**To:** T10 Parallel SCSI Working Group  
**From:** Russ Brown  
**Email:** russ\_brown@maxtor.com  
**Date:** ~~22 February~~ 12 March 2002

**Subject:** Proposal for Offset Correction for Ultra640 SCSI for SPI-5

Figure A.y - Input Signal Offset Component  $V_{RXOFFSET}$

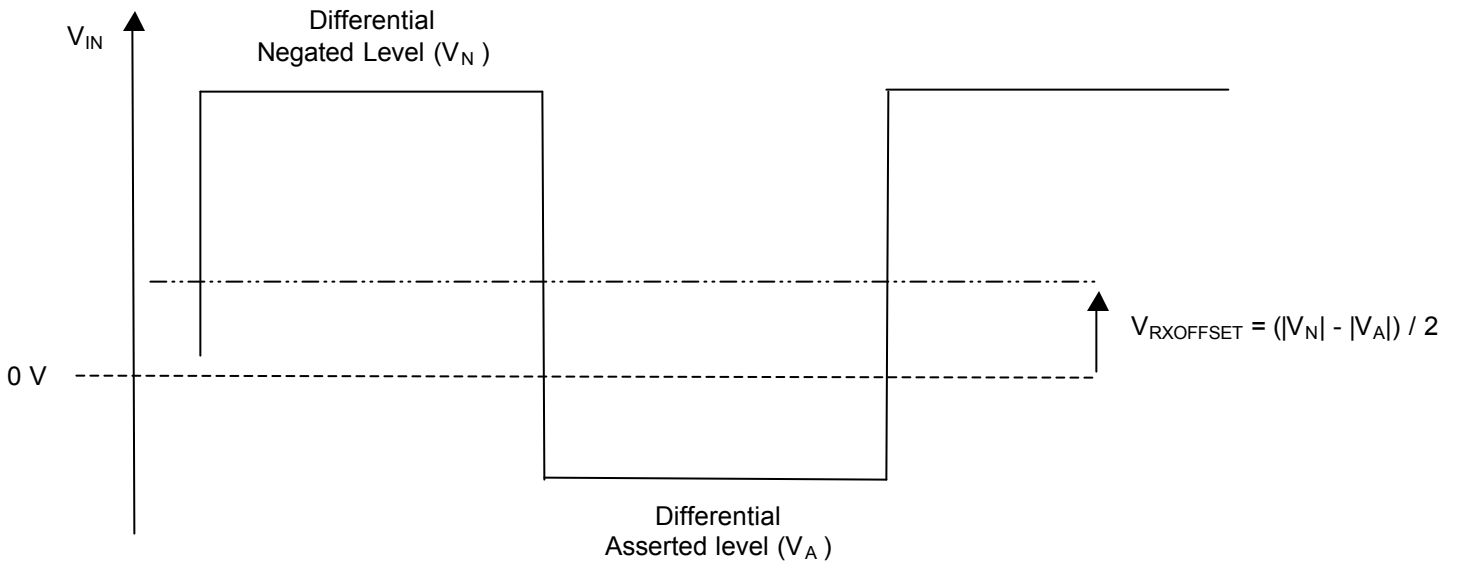
Table A.x and Figure A.y define the voltages for the requirements in this subclause. [This subclause places requirements on receivers only and does not change input signal requirements.](#)

The differential offset component of the receiver input voltage is defined as:

$$V_{RXOFFSET} = ( |V_N| - |V_A| ) / 2$$

where  $|V_A|$  and  $|V_N|$  are the steady state differential Asserted and Negated signal levels applied to the receiver, measured after 100 ns assertion (negation) of the signal.

Within the common-mode input voltage range ( $V_{CM}$ ), of  $0,845 \text{ V} < V_{CM} < 1,655 \text{ V}$  (see table A.7) and after calibration on a training pattern containing a differential offset voltage component,  $V_{RXOFFSET}$ , a Fast320 receiver shall detect assertion and negation with  $V_{IN}$  in the ranges shown in Table A.x, and over an input signal offset range of  $-75 \text{ mV} < V_{RXOFFSET} < +75 \text{ mV}$  (see figure A.11 for the test circuit for  $V_{IN}$ ).
